Item Name: Repl. Skidtube Low Gear (Run On Landing) LH or RH

| DRAWING NO. D3804 | TITLE SKIDTUBE ASSEMBLIES, 206A/B | REV. A | DART AEROSPACE LTD ENGINEERING ORDER | | D.E.O. NO. D3804-A-1 | SHEET NO. SHEET 1 OF 1 | SCALE NTS |

CHANGE C'BORED WELDED CROSSBOLT SPACERS TO SWAGED SPACERS

DETAIL B
SCALE NONE
C3-2
C3-3

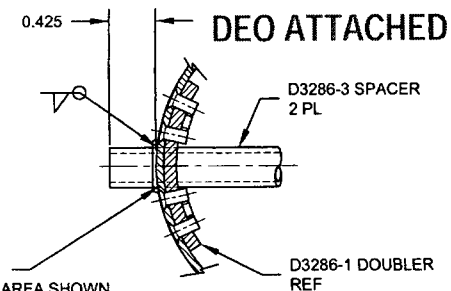
1-Open holes of detail B to finished size as per Dwg DEO D3804, (without cutting fluid)

2-C'sink one crossbolt spacer hole as per Dwg D3804 DEO Detail B(without cutting fluid)

AMENDMENT TO DETAIL B
NOT TO SCALE

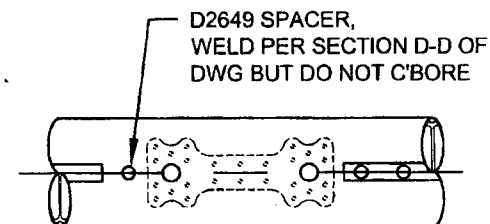
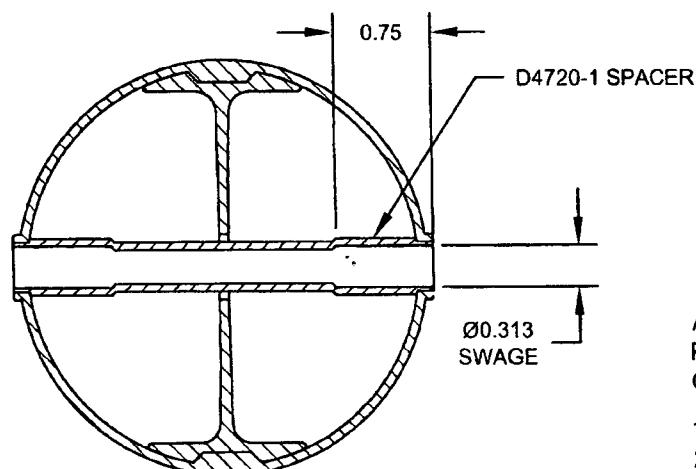
ADD SECTION H-H BELOW, WHICH IS THE SAME SECTION VIEW AS SECTION D-D OF DWG.
C'BORED HOLES ARE **NOW SWAGED** PER SECTION H-H BELOW. FOR THE Ø0.375 HOLE THAT IS NOT C'BORED, WELD PER SECTION D-D OF DWG (SEE AMENDED DETAIL B FOR REFERENCE).
